# MEMORANDUM

Re: Proposed Grade Change  
County Rd. 7 at Highland Creek  
Structure Site No. 14-282, W.O. 93-11015  
District 1, (Chatham)

Re: Proposed Grade Change at the County Road 7 Bridge  
Highland Creek - Lambton County, Ontario  
Stability Assessment of the Slope

Re: Geotechnical Review No. 2 of the Proposed Grade Changes at the  
County Road 7 Bridge over Highland Creek - Lambton County, Ontario

SECTION THROUGH HOLES 2 & 1

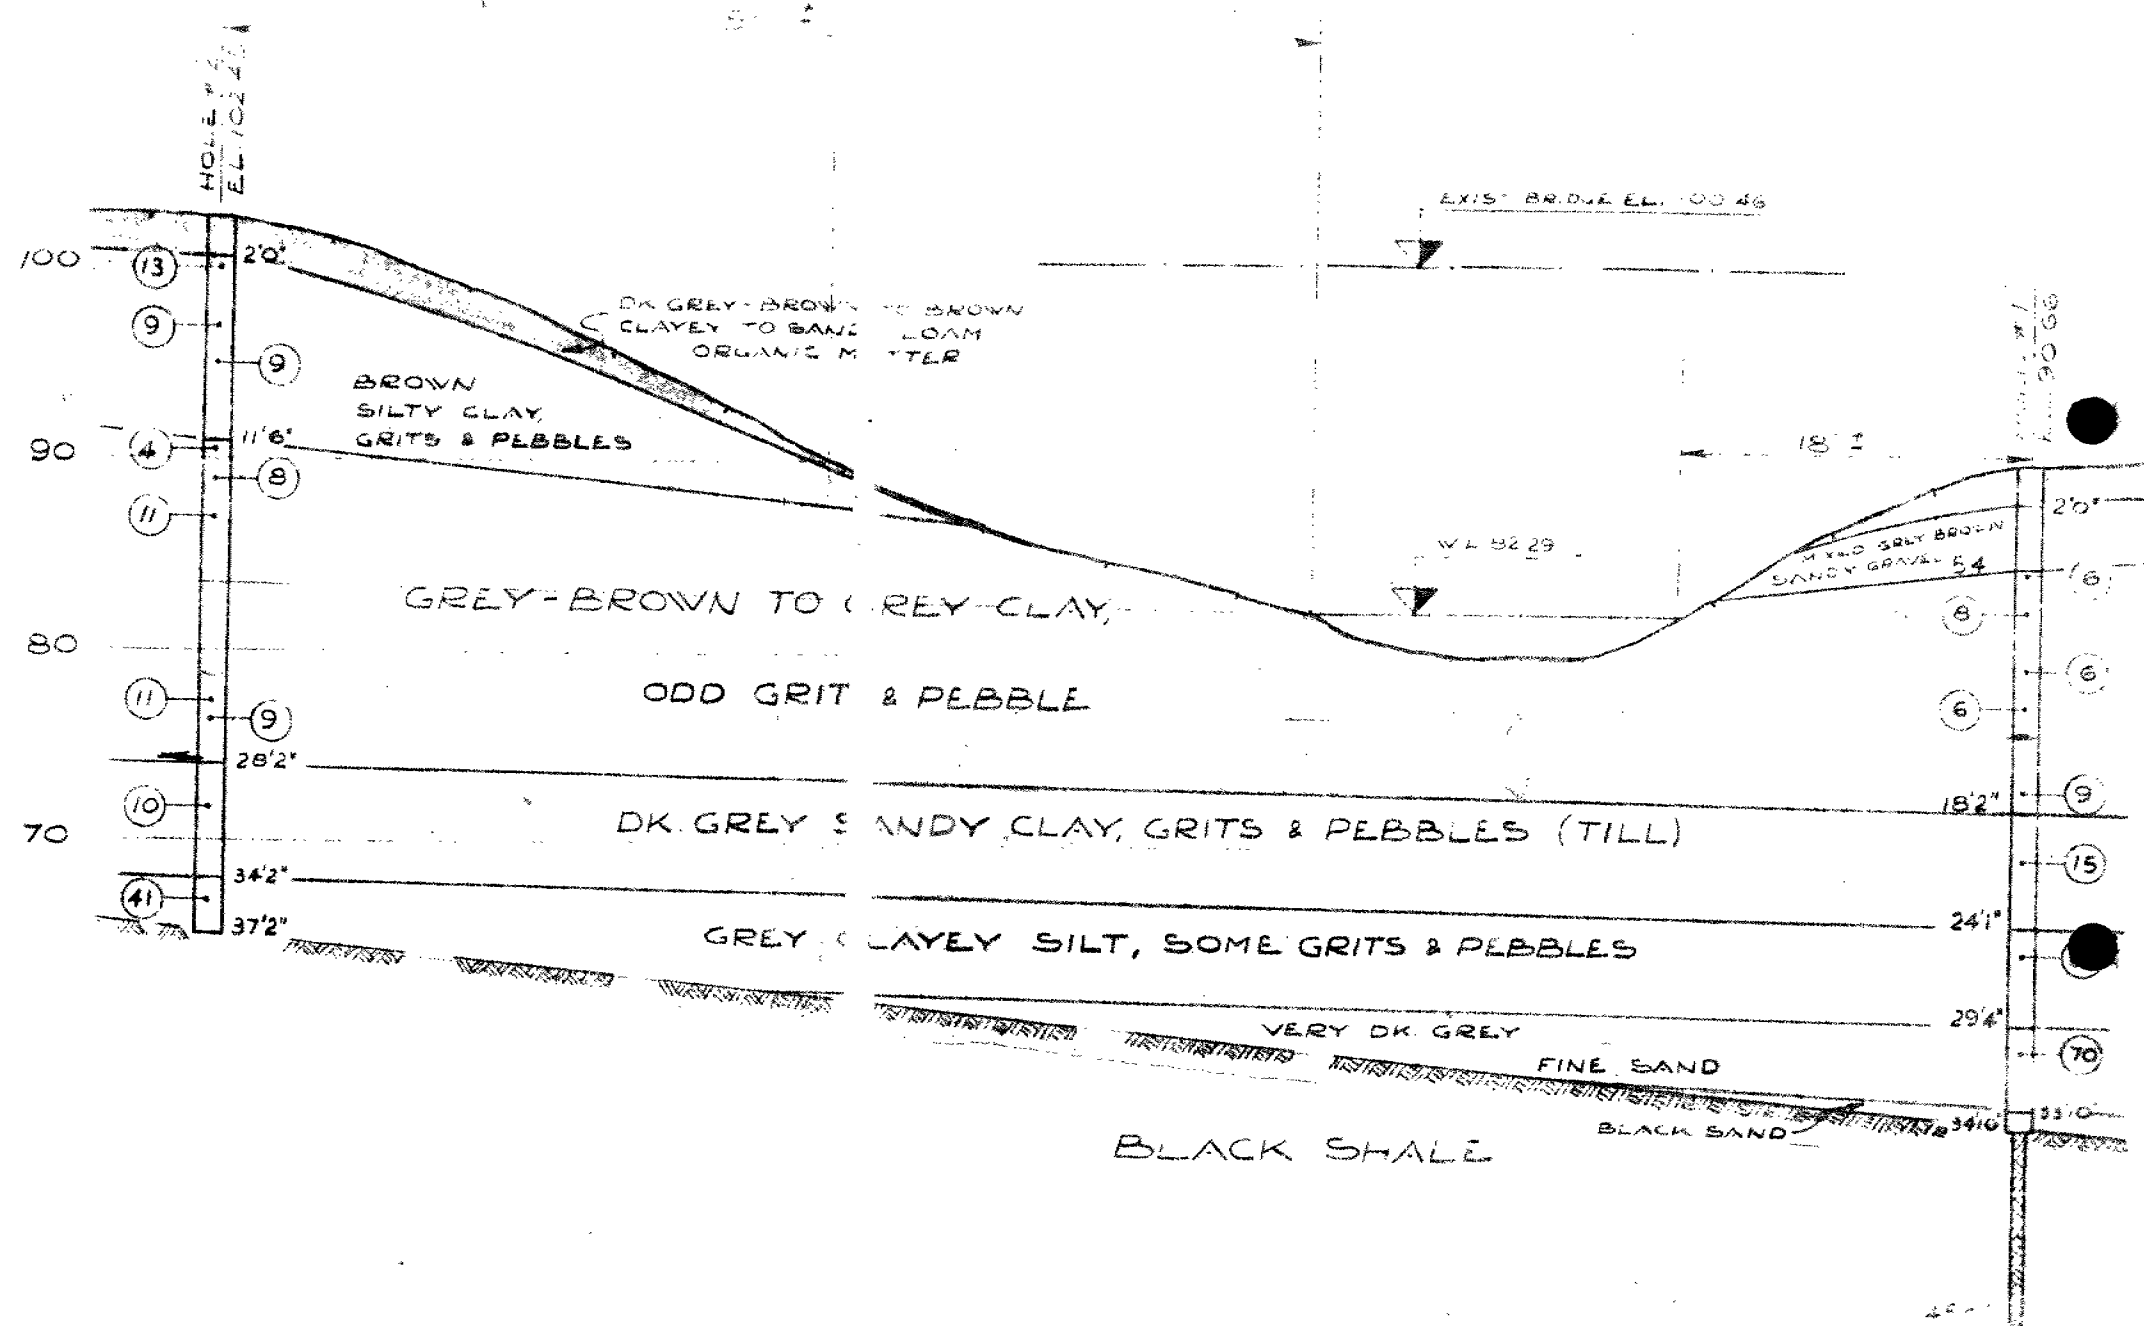
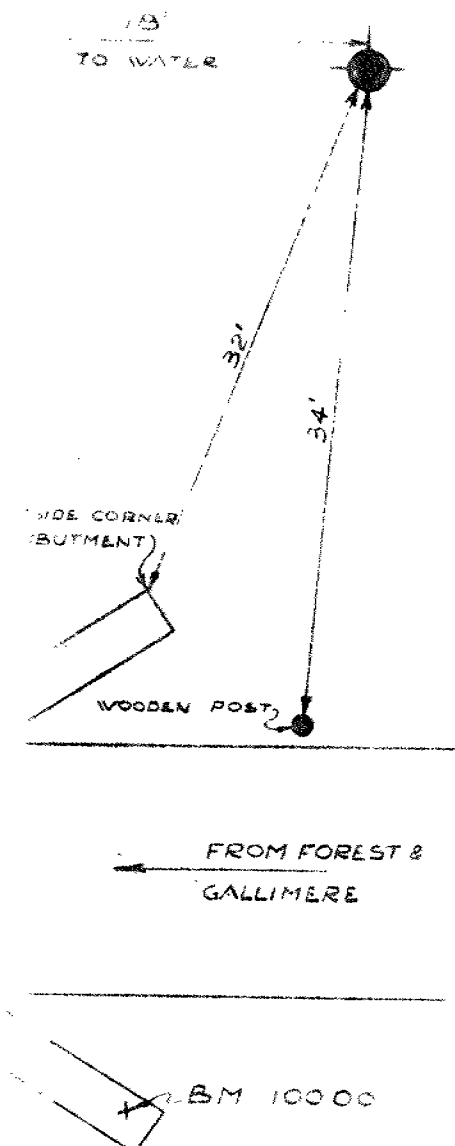
- 1) Design Drawing #2 indicates that the existing profile grade will be increased by about 3 to 4 ft. The photographs taken at this site show horizontal movement of the existing guardrail, which indicates a somewhat unstable condition.
- 2) In our opinion, the additional load will aggravate this situation.
- 3) The construction of the proposed bin-type retaining walls on the existing slope will require extensive excavation which in turn may jeopardize the integrity of the travelled road.
- 4) The magnitude of the additional settlement?
- 5) Will the buried utilities withstand the additional settlement?
- 6) Will benching be required?

In this respect we have looked to a conservative assumption in which the existing embankment and the proposed addition were assimilated with a permanent surcharge of approximately 2300 psf (for the existing embankment) plus 500 psf (carried on by the addition) acting over the foundation soil at the river bed level. No shear strength was assigned, at this stage, to the embankment fill. According to the above schematic, the risk

As presented within the original soil report prepared by E.M. Peto Associates Ltd. in 1961 and confirmed during our soil investigation of 1992, a minimum allowable pressure of 2100 psf is available at the river bed elevation. This allowable pressure incorporates a factor of safety of a minimum of 3. Consequently, the actual bearing capacity of the foundation soil is assessed to a minimum of 6300 psf and, therefore, the effective safety factor against the general failure under a total applied load of 2800 psf is in excess of 2.
